State of California
Department of Water Resources
Sustainable Groundwater Management Program
Alternative Assessment Staff Report

Groundwater Basin Name: Sacramento Valley - South American (5-021.65)
Submitting Agency: Sacramento Central Groundwater Authority
Recommendation: Do Not Approve
Date Issued: July 17, 2019

Figure 1 – Sacramento County Groundwater Basins – Central Basin Boundary Compared with South American Subbasin Boundary

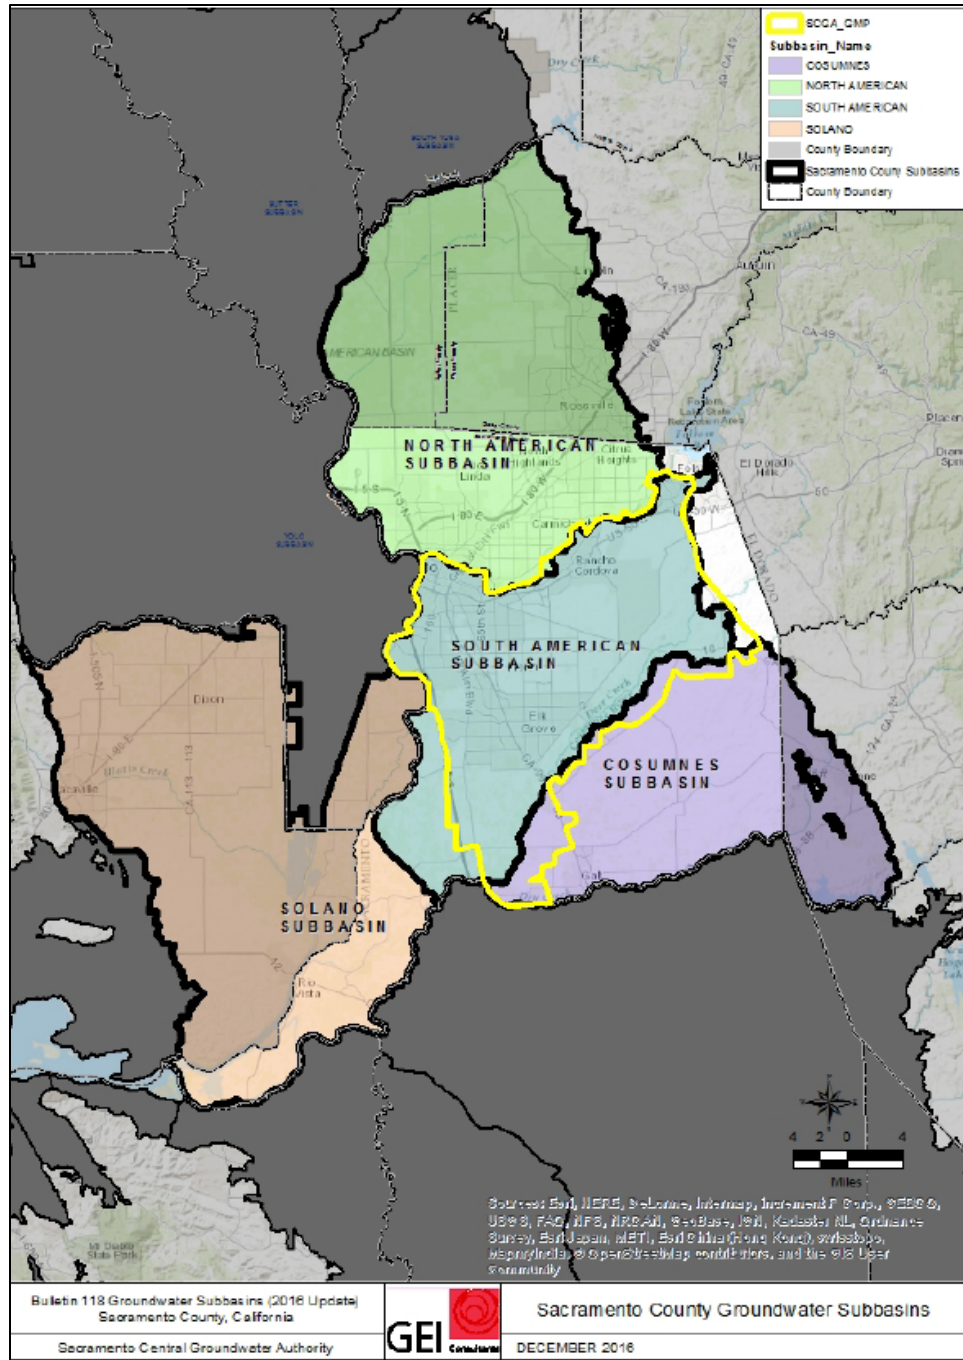
documents as the Central Basin (outlined in yellow on Figure 1).³² The boundaries of the Central Basin overlap, but do not entirely cover the South American Subbasin (shown in teal on Figure 1) as defined in Bulletin 118. The Central Basin does not include the southwestern corner of the South American Subbasin, which lies in the Sacramento-San Joaquin Delta,³³ and extends south into the adjacent Cosumnes Subbasin (shown in lavender on Figure 1), as well as exhibiting other minor boundary deviations. To demonstrate that the SCGA groundwater management effectively covers the entire basin, SCGA presents an analysis to relate the sustainable yield defined for the Central Basin to the South American Subbasin.³⁴

To determine whether the Alternative effectively covers the entire Subbasin, Department staff are required to determine whether groundwater management pursuant to the Alternative has avoided undesirable results in the entire Subbasin for at least 10 years. Because Department staff have determined that the Analysis of Basin Conditions does not demonstrate that undesirable results have been absent for at least 10 years, even

within the locally-defined Central Basin, the Department staff are unable to determine the South American Subbasin has been managed sustainably. As a result, Department staff cannot conclude that the Alternative effectively covers the entire Subbasin. Although the failure to cover the entire Subbasin precludes the Alternative from approval, Department staff note that the failure to effectively cover the entire Subbasin is a consequence of the Alternative not demonstrating sustainability in the area within SCGA's jurisdiction. Department staff do not express an opinion as to whether the area managed by SCGA would be sufficient to effectively manage the entire South American Subbasin if sustainable groundwater management had been sufficiently demonstrated.
